## **Deviation Request Package Coyote Valley Dam - Lake Mendocino**

### **Introduction**

**Figure 3. Existing Guide Curve and Proposed Guide Curve with Requested Changes.**

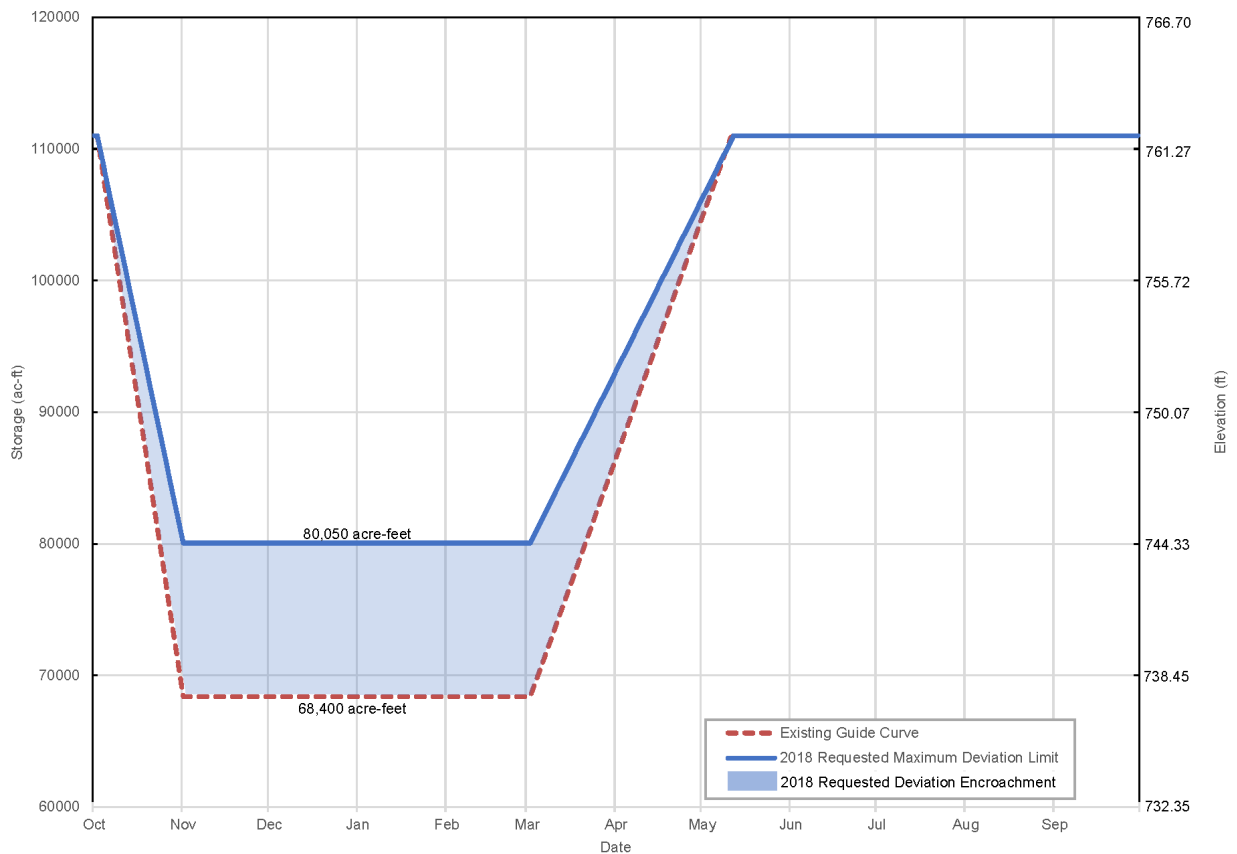
Members of the FIRO Steering Committee are requesting USACE approval of a planned major deviation to store additional water above the existing guide curve for the Coyote Valley Dam Lake Mendocino WCM within the shaded region shown in Figure 3. If approved, this would result in a maximum additional storage of 11,650 acre-feet between November 1 and February 28. Figure 3 below shows the existing guide curve for the Coyote Valley Dam Lake Mendocino WCM and the proposed guide curve with the requested changes. Table 1 provided in Appendix A summarizes the daily maximum deviation limit values.
